Environmental Assessment Addendum

Replacement Flows Project –
Cumberland Plain Woodland area near
Penrith STP

May 2008

Figure 3.7a from EA

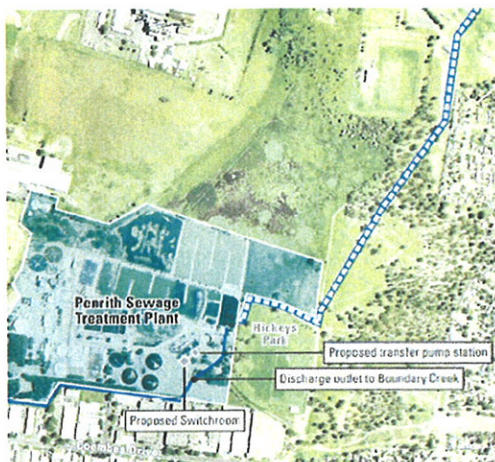
Although the EA drawings (Figure 3.7a extract and Figure 3.5a extract) show the pipeline following a straight alignment through the Cumberland Plain Woodland area, the exact alignment of this section of pipeline was described in the Flora and Fauna report (Appendix E of EA) as follows:

Although the EA drawings (Figure 3.7 and 8.1a above) indicate that the pipeline follows a straight alignment from the Penrith STP northeast towards Andrews Road, the sealed pathway is actually very circuitous. **Figure 1** shows a more accurate depiction of the sealed pathway through the Cumberland Plain Woodland area.

It is proposed that the two pipes would be installed in this straighter, previously cleared corridor. The old sewer pipe is likely to be removed prior to installation of the two new pipes. This would take the pipeline route away from the sealed pathway adjacent to the Freshwater Wetland (see **Plate 1**), through a cleared area and in a straight line through the Cumberland Plain Woodland area (see **Plate 3** below).

The sealed pathway (EA alignment), existing sewer alignment and proposed alternate pipeline alignment are shown on **Figure 1**.

Figure 8.1a High value conservation areas

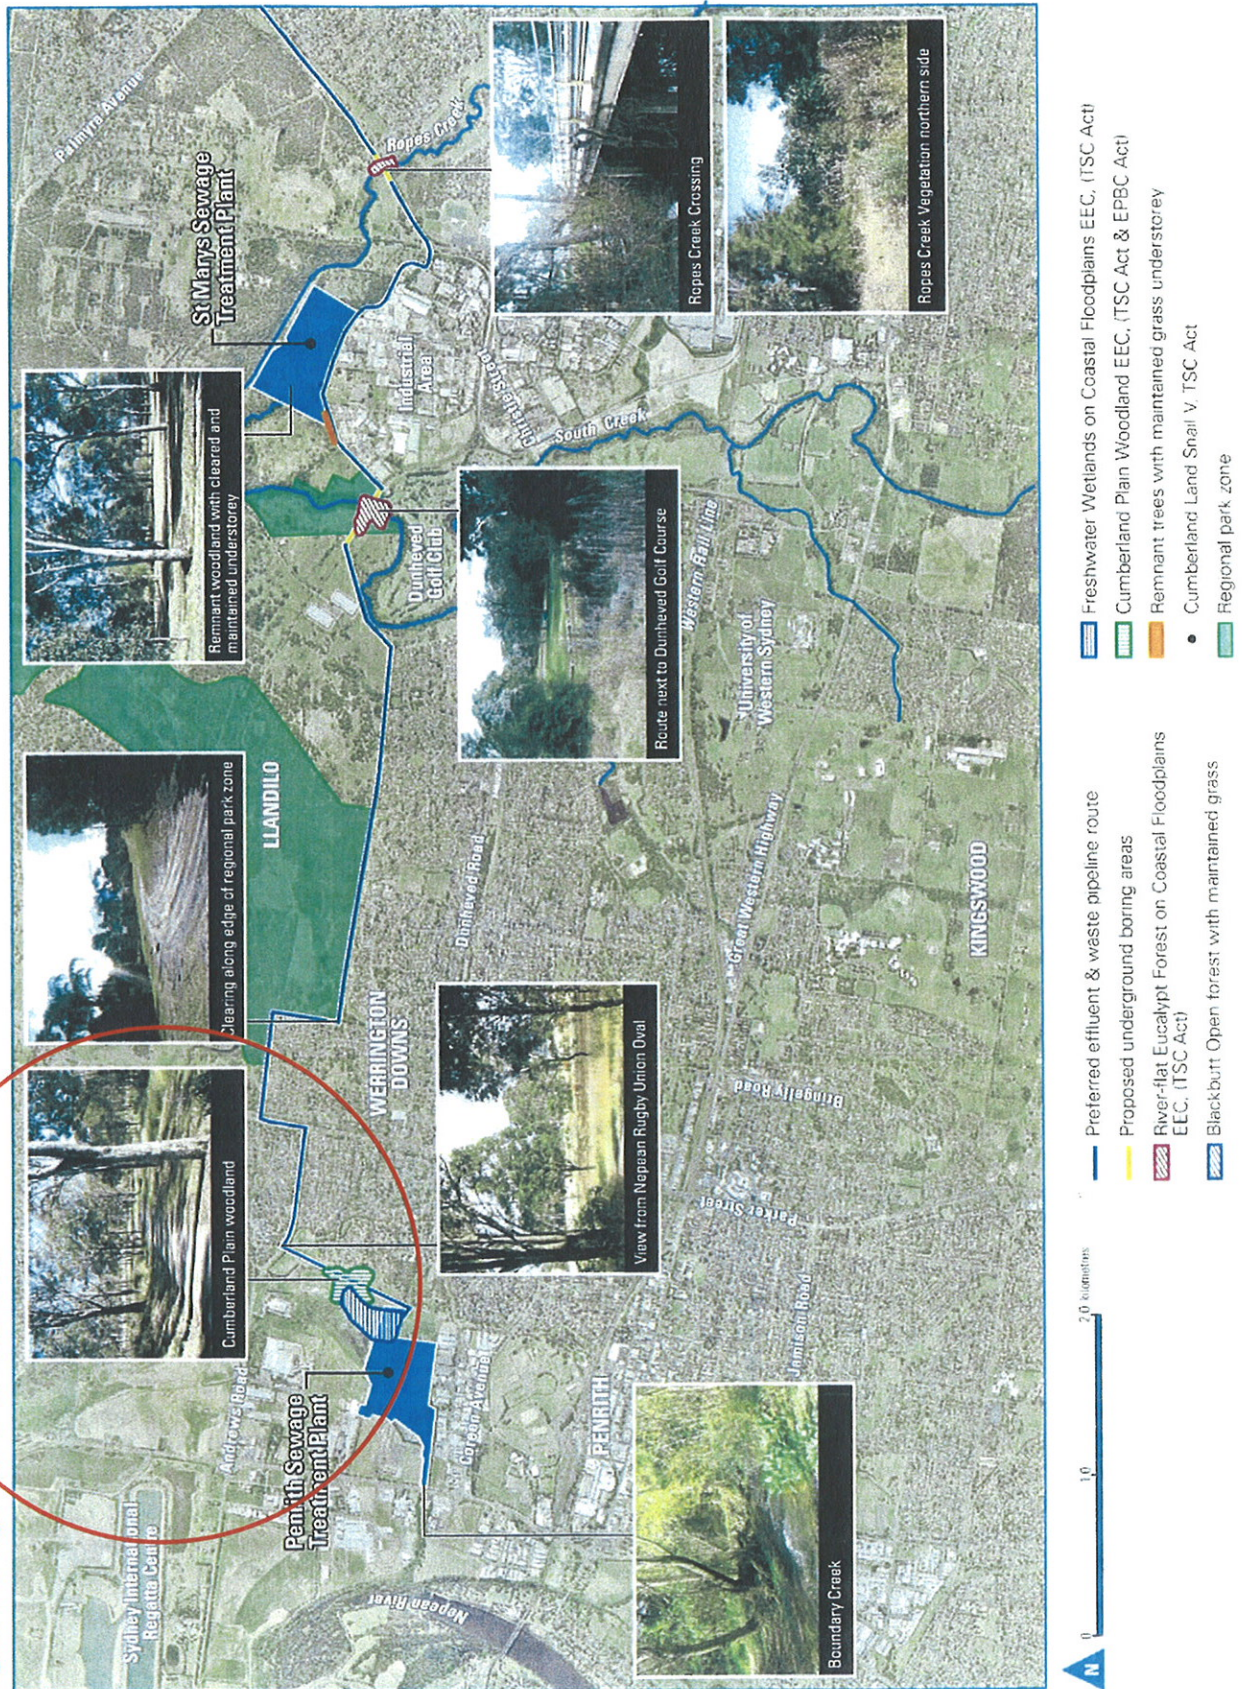
Figure 8.1a from the EA (see next page) also shows the pipeline following the pathway through the Cumberland Plain Woodland.

The original EA alignment was also located adjacent to a Freshwater wetland area (Figure 8.1a from EA). It was observed on-site in early 2008 that the wetland area had encroached slightly northward into the proposed pipeline alignment due to prolonged rainfall periods occurring in early 2008. Therefore the other benefit of the proposed re-alignment is that the pipeline construction would be moved approximately 100m further north, well away from the wetland area and any potential habitat for the Green and Golden Bell Frog.

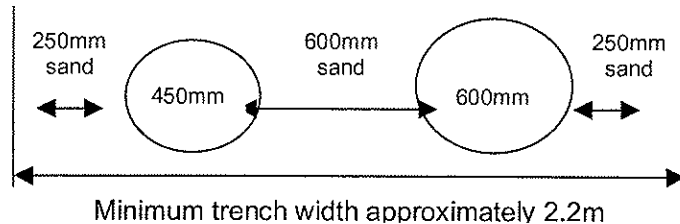
The design requirements for the installation of the twin pipelines in this section are as illustrated below:

Sydney Water's maintenance requirements mean that the minimum width of the trench to be excavated within this section of the project is 2.2m. This width is necessary to allow the two (2) pipes to be installed side by side. Stabilised sand also needs to be backfilled around the pipes (minimum width of 600mm between them and 250mm either side) for protection of the pipelines.

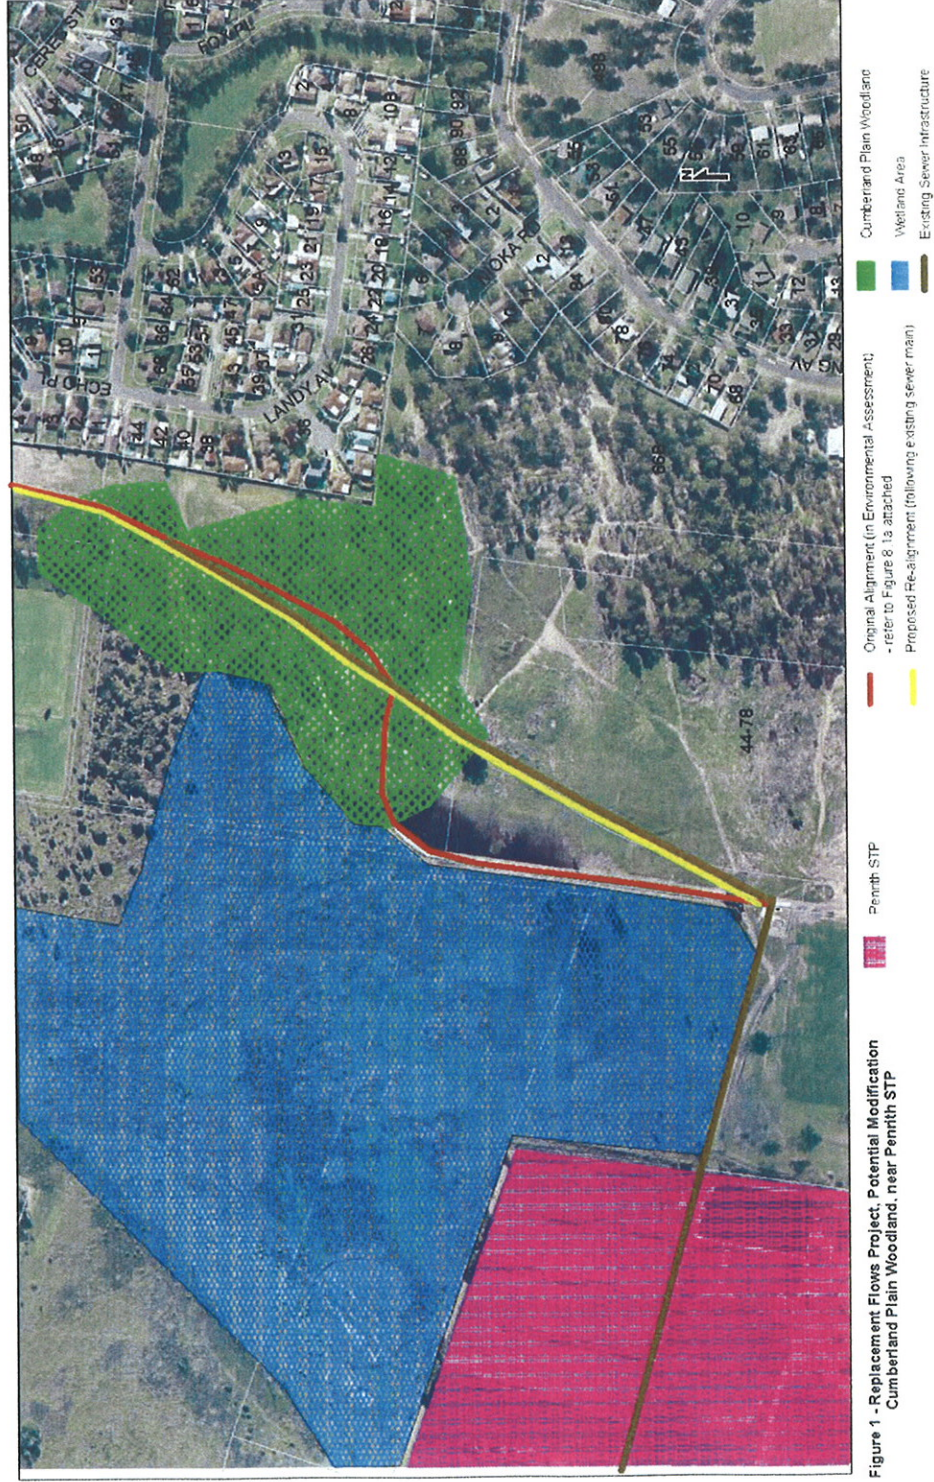
During detailed design and site investigations in early 2008 by the Contractor it was discovered that the width of the sealed pathway and associated 'clear' area in between trees was approximately 2.5m along most of the path's length (as can be seen from **Plate 2** above). This means that in order to install both pipes along the existing sealed pathway (as per the original EA alignment), trench excavation would need to occur right up against the tree trunks and into the critical root zone area of the adjacent trees. Excavating through critical root zones would either require immediate tree removal due to stability issues or cause possible tree death over the long-term.

If the pipeline were installed within the sealed pathway, bends would be required in the pipeline alignment. At each bend, concrete thrust blocks would be required to ensure that the pipeline is sufficiently founded for additional pressure stresses at the pipeline bends. This means that at each bend, the width of excavation would need to be increased an additional 1m beyond the normal pipeline trench width to install the concrete thrust blocks. This would result in greater impacts to adjacent trees and/ or the adjacent wetland area than a straight pipe alignment.
